Conceptual Review Agenda

Schedule for 08/29/16 to 08/29/16

CONCEPTUAL REVIEW: APPLICATION

Re: 1800 E Prospect Rd - Plant Nursery

Google earth

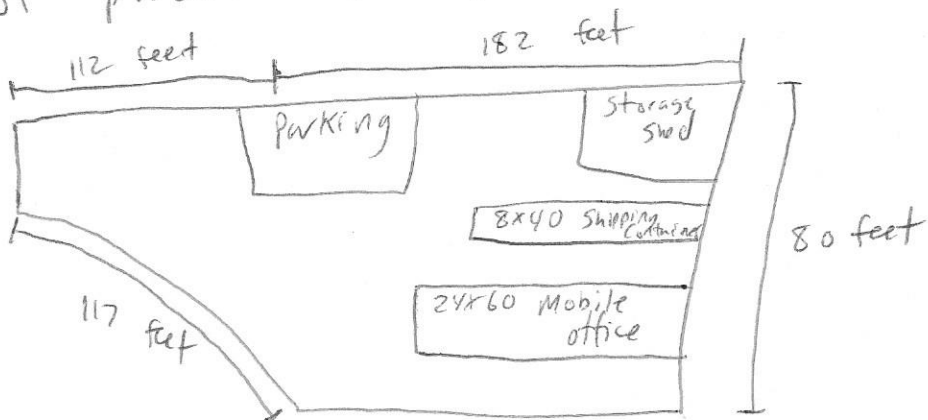
5. Will there be any lighting on the site? If so, please provide a photometric plan and specifications for light fixtures with your PDP submittal.
6. The parcel shown on the site plan sketch does not have legal access to Riverside or Prospect. Please see comments from Engineering about possibilities for conveying this land as a legal lot.

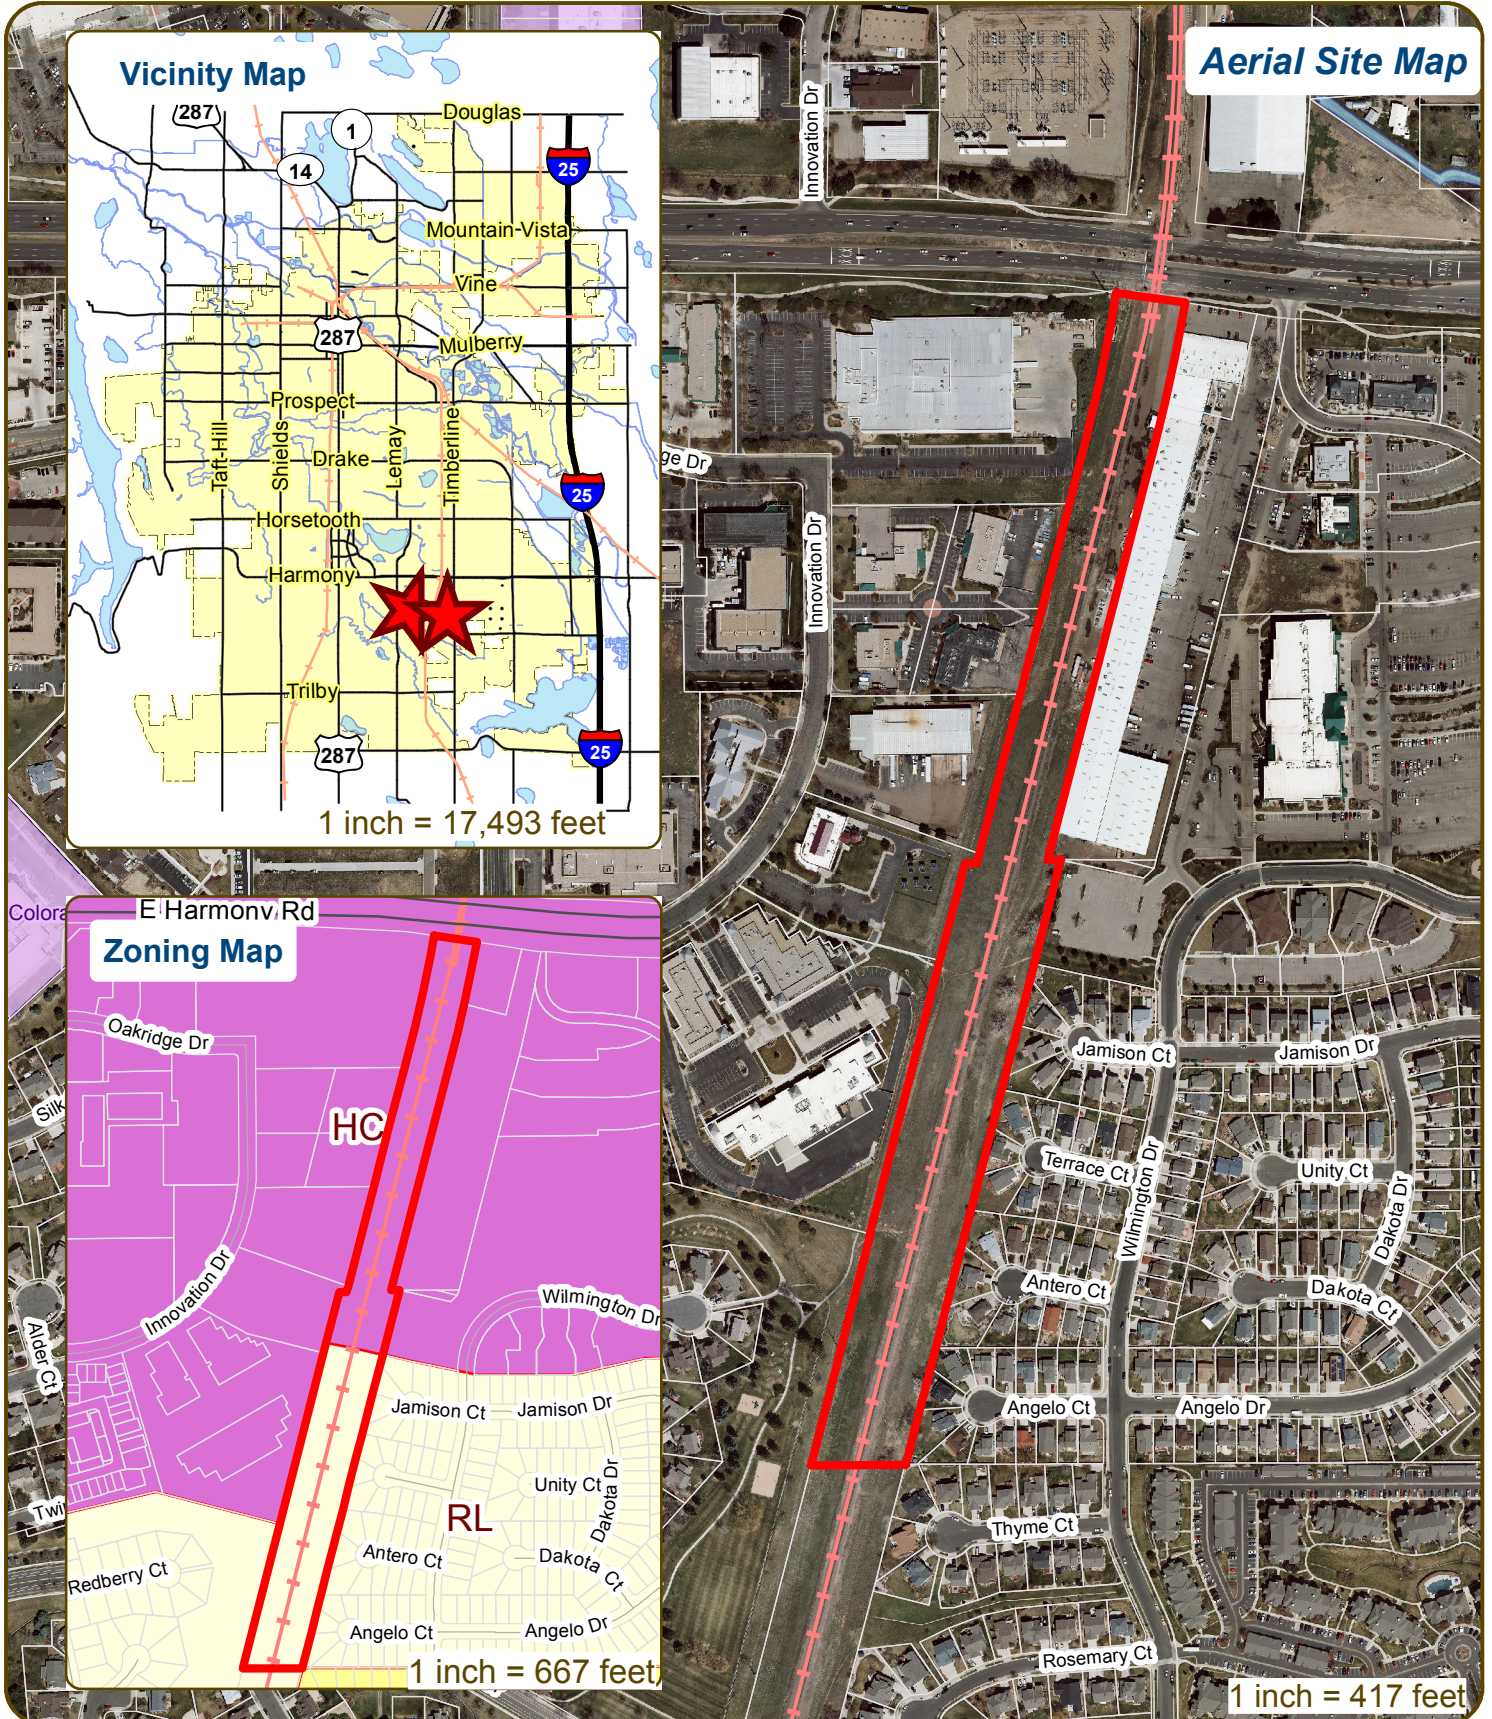
1. On the site plan, it is not clear how the 2 basement parking spaces will not interfere with the existing main unit garage parking access. The proposed change to the stairs seems to conflict with the parking space.

SHEET TITLE:	SITE PLAN
--------------	-----------

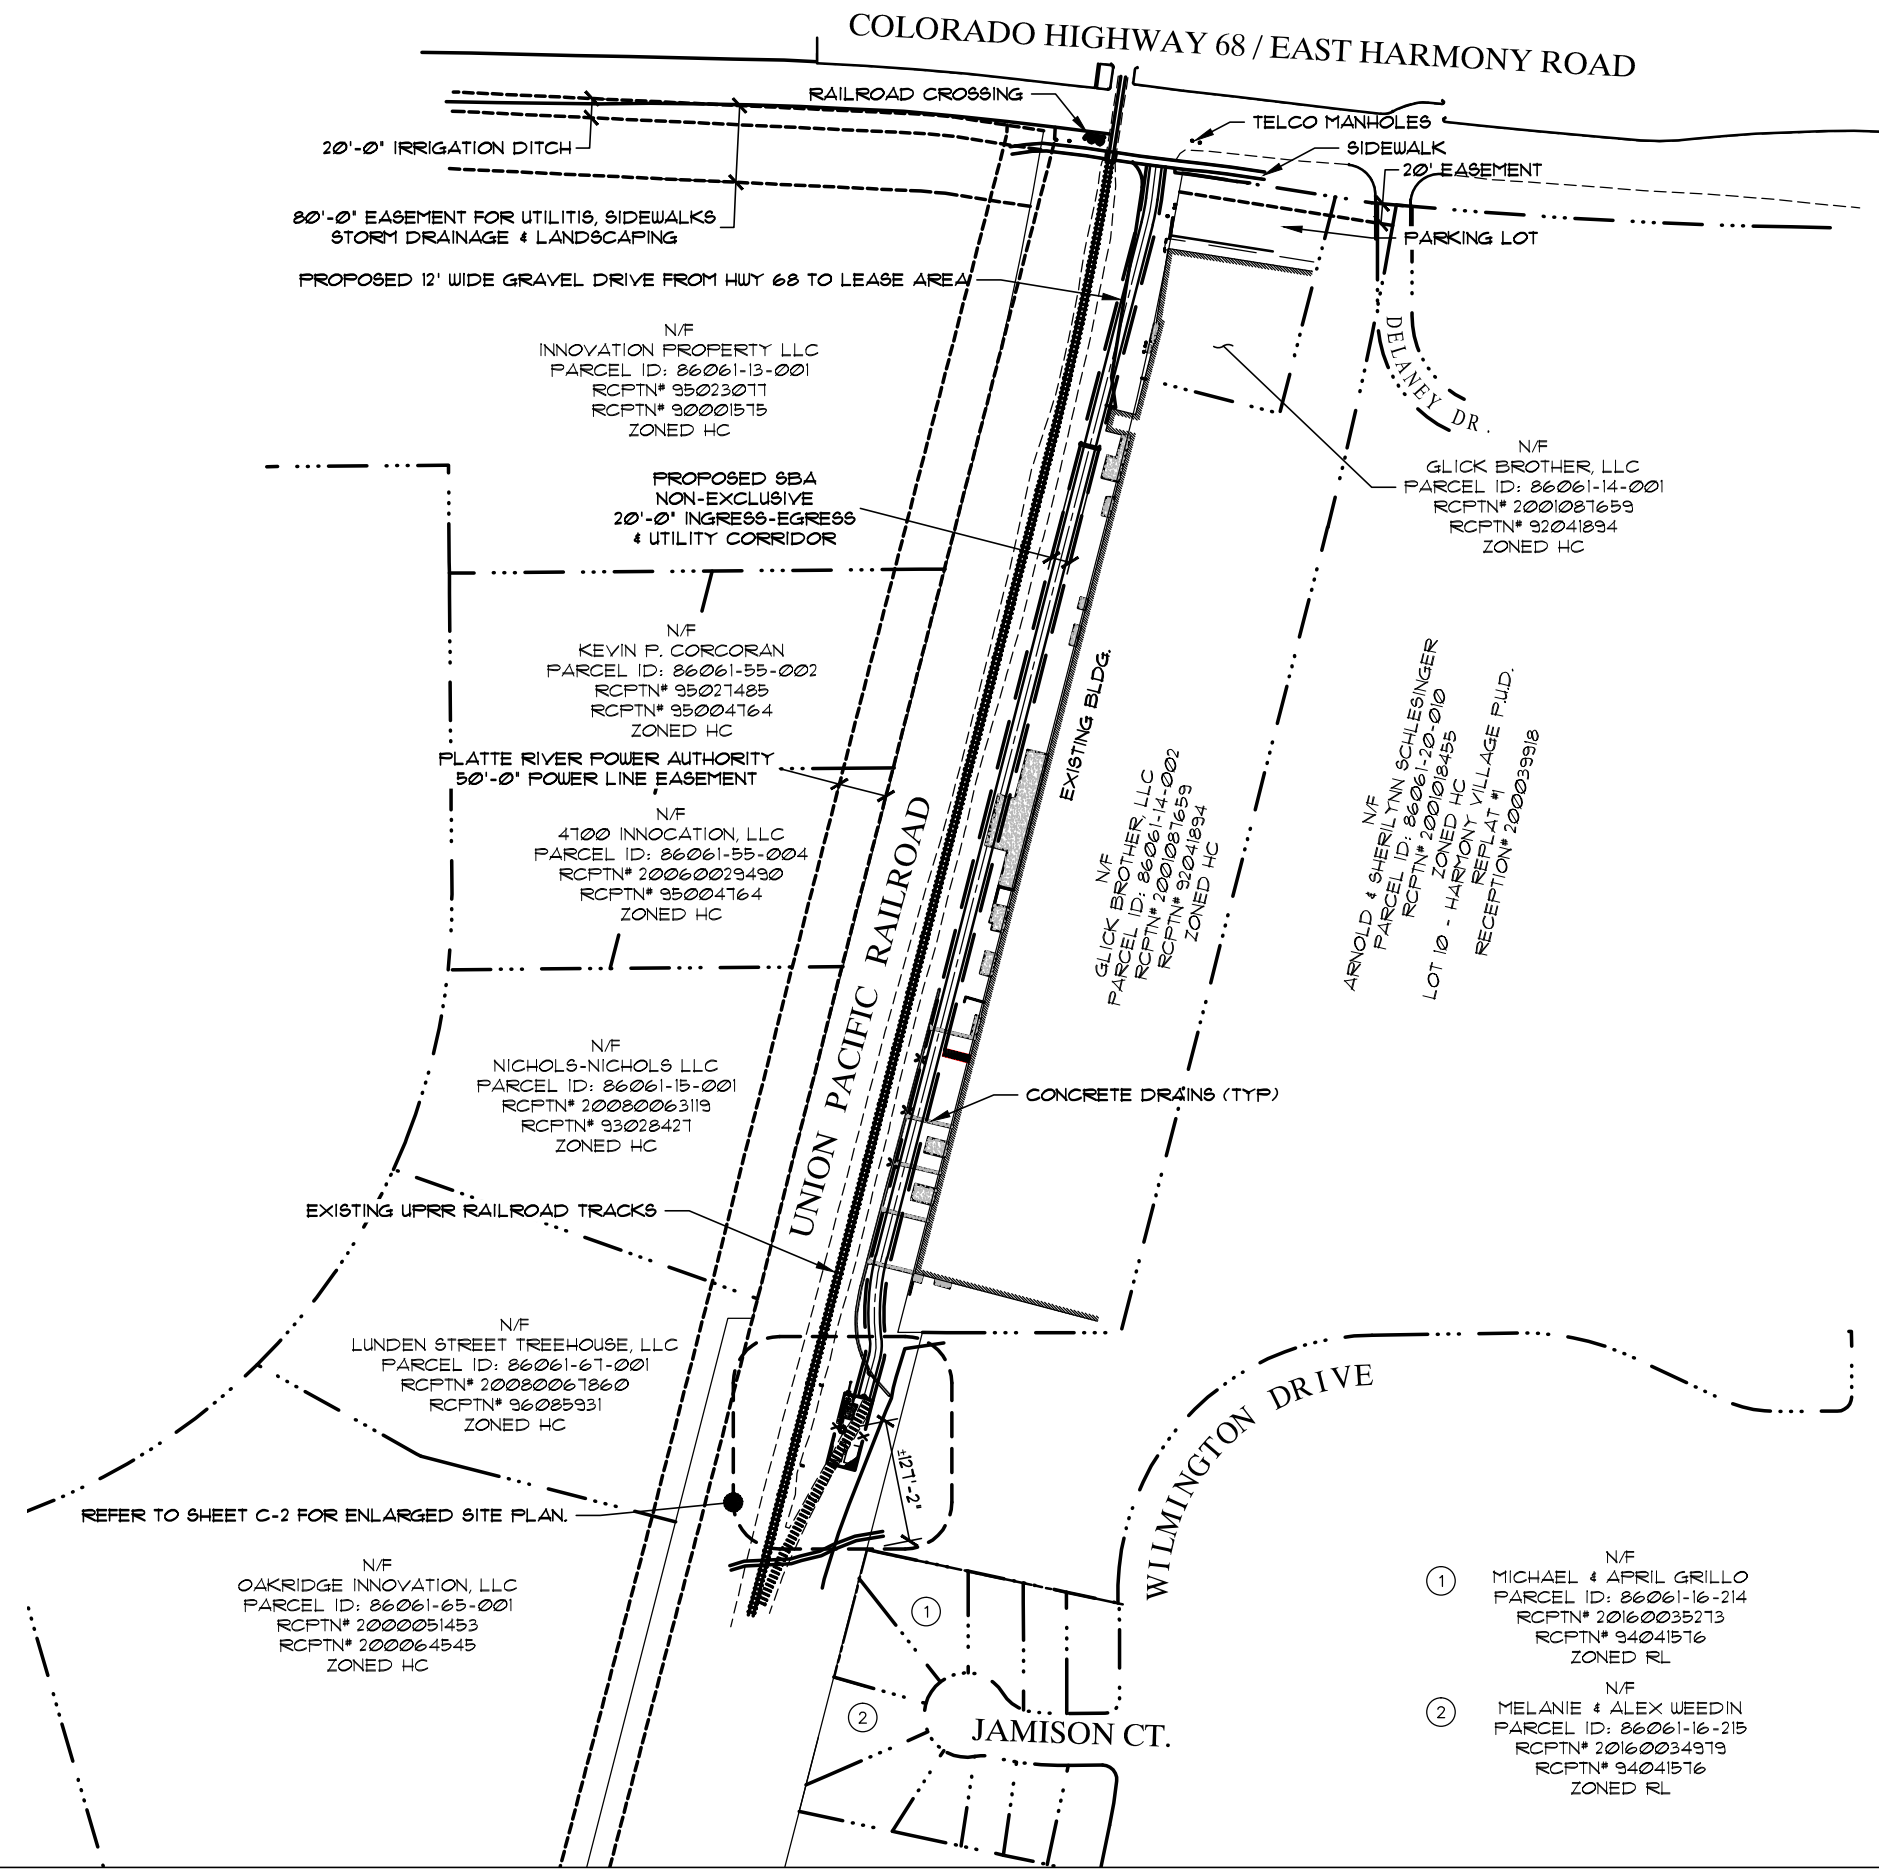
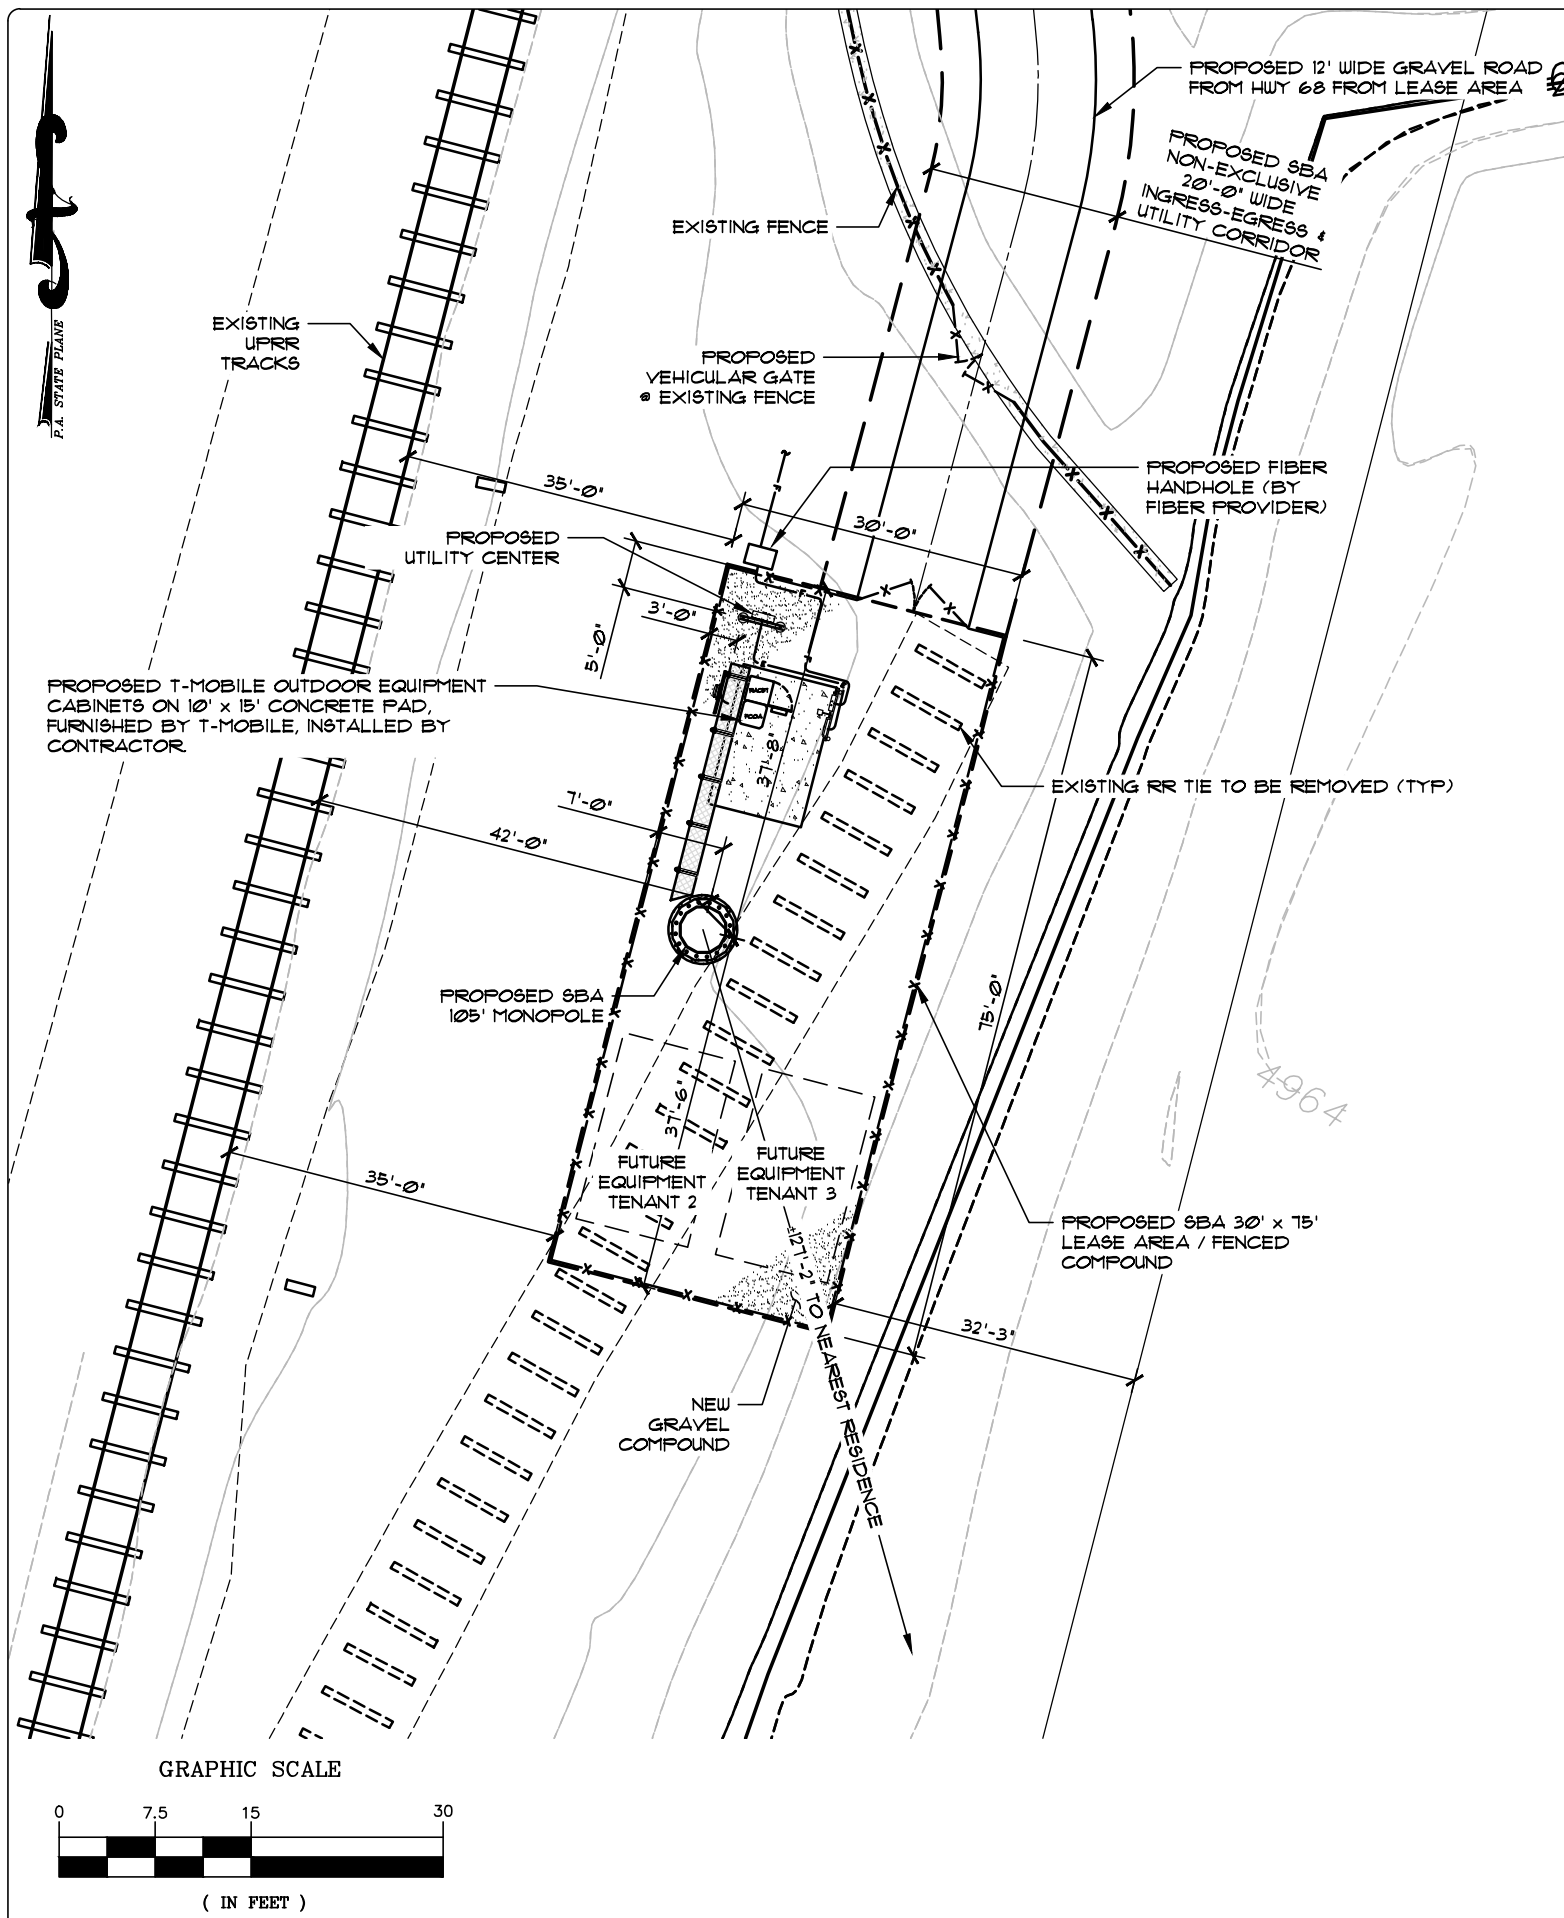
6. The proposed access onto Harmony Road is awkward from the perspective that the City's adopted access control plan Harmony Road does not identify this location as a prescribed access point for development (understanding that the railroad has utilized this for their operation, it was not identified as an access point for development). Given the input from PFA regarding an emergency access easement, it would be much preferred if both emergency access and access to the site were secured from existing land and roadway infrastructure to the east. Formally proposing access off of Harmony Road would require additional review and City consideration.

1. The proposed facility does not appear to meet the setback standard listed in LUC 3.8.13(C) (1). This requires a tower setback of 1 foot for every foot of height from property lines.

2. The current design proposed does not meet the LUC requirements and must be modified. The LUC requires that stealth design be used with the design of the tower to mitigate and/or camouflage visual impacts. Provide with the application narrative an analysis of your tower design and location choices within the immediate area. Are there other locations in the vicinity that are better suited, are there existing structures or buildings nearby where the equipment can be better located, are there suitable mimic structure designs that can be employed at these locations.
